PLAN REVIEW SHEET

Petition #: RZP 2021-159

Address: 601 West Sugar Creek Rd.

Request: UR-2 (CD)

WAITING PAD WITH 5'X10' BOX SHELTER WITH PLANTING STRIP

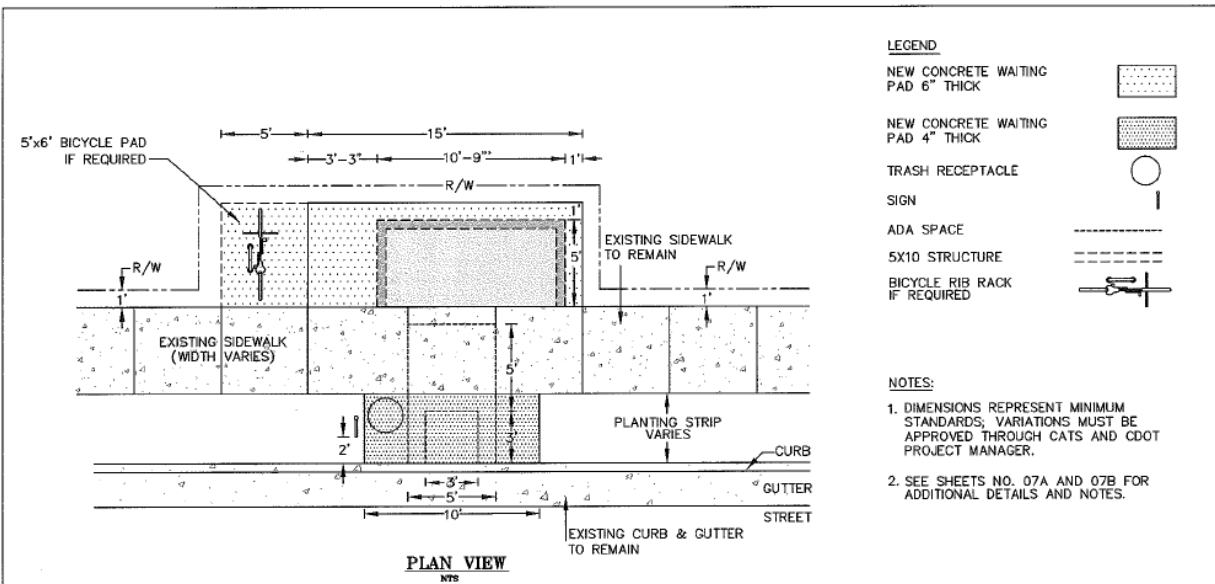
The site is located along CATS local bus route #211 on West Sugar Creek Rd. CATS requests the construction of a bus shelter pad and ADA compliant waiting pad per Land Development Standard 60.03A along West Sugar Creek Rd. The final location of the pads will be coordinated with the developer through the permitting process.
